FT-2000 Manual Erratum

There is an unfortunate error in the FT-2000 User Manual regarding dual diversity reception entitled Polarity Diversity on Page 44.

Simplified diagram of FT2000 Aerial Selection

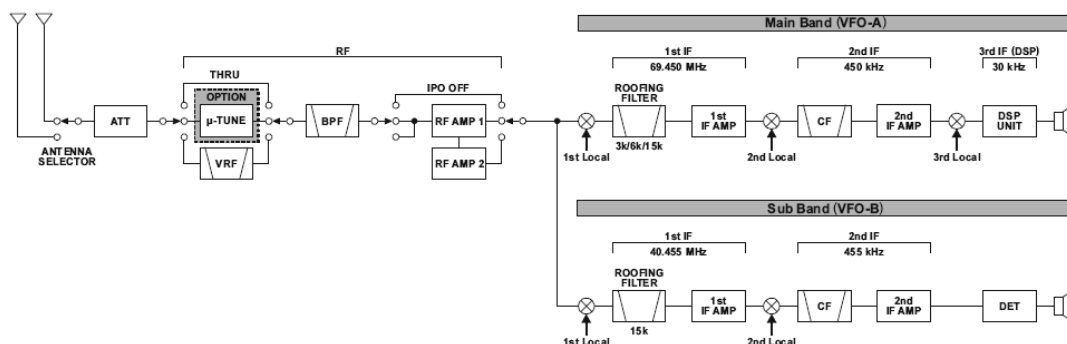
This section states that the FT-2000 can be set-up for dual diversity reception where the main receiver is connected to one aerial and the sub receiver to another separate aerial.

Dual diversity reception implies that the same signal is received on two aerials connected to independent receivers and then combined at the demodulation stage or later. Both receivers therefore need to have separate aerial inputs, front end tuning as well as separate IF Stages etc.

The Main and Sub receivers in the FT-2000 share a common aerial selection, front end tuning and band pass filtering as shown in the diagrams below and consequently dual diversity reception is not possible on this model.

Vertex Standard regrets any confusion this error may have caused and has taken steps to rectify the error in the manual.
